Access Compliance Report

Public Rights-of-Way

(Curb Ramps)

Intersection ID: 18844	Main Street: NATIONS_FORD_RD	Cross Street: TYVOLA_RD	Location: NW
ADA ID: 1C0348A3D215	Ramp Type: PerpDiag	Initial Pass/Fail: Fail	Overall Compliance: No
Severity Score: 22.5			
Codes/Mitigation Info/Possible Solution		Field Measurements/Component Compliance

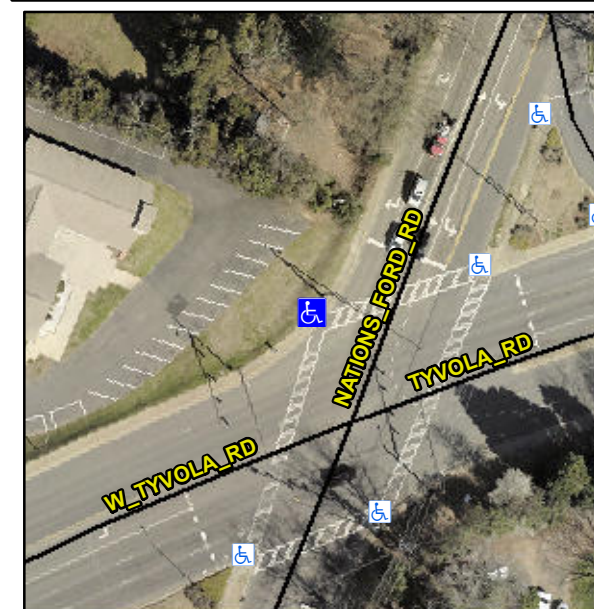
Not Found, R304.5.1, R304.2.2, R304.5.3

Compliance	Description	Data	Compliance	Description	Data
N/A	Ramp Length (in)	58.0	No	Ramp Slope (%)	9.6
No	Ramp Width (in)	40.0	No	Ramp XSlope (%)	2.1
N/A	Flare Type LT	N/A	N/A	Flare Type RT	N/A
N/A	Flare Slope LT (%)	N/A	N/A	Flare Slope RT (%)	N/A
N/A	Flare Traversable LT?	N/A	N/A	Flare Traversable RT?	N/A
N/A	Landing Length (in)	N/A	N/A	DWS Provided?	N/A
N/A	Landing Width (in)	N/A	N/A	DWS Contrast?	N/A
N/A	Landing Slope (%)	N/A	N/A	DWS Length (in)	N/A
N/A	Landing X Slope (%)	N/A	N/A	DWS Full Width?	N/A
N/A	Landing Curb? (Y/N)	N/A	N/A	DWS Offset (in)	N/A
N/A	Shared Landing?	N/A			
N/A	Gutter Ponding?	N/A	N/A	Gutter Slope (%)	N/A
N/A	Gutter Lip Ht (in)	N/A	N/A	Gutter X Slope (%)	N/A
N/A	Painted X Walk1?	Yes	N/A	Painted X Walk2?	Yes
	X Walk 1 Direction	To SW		X Walk 2 Direction	To E
N/A	X Walk 1 Width (in)	67.0	N/A	X Walk 2 Width (in)	105.0
	X Walk 1 Slope (%)	0.5		X Walk 2 Slope (%)	0.6
	X Walk 1 X Slope (%)	2.0		X Walk 2 X Slope (%)	0.5

Remove & Replace Curb Ramp With Two New Directional Ramps or Equivalent.
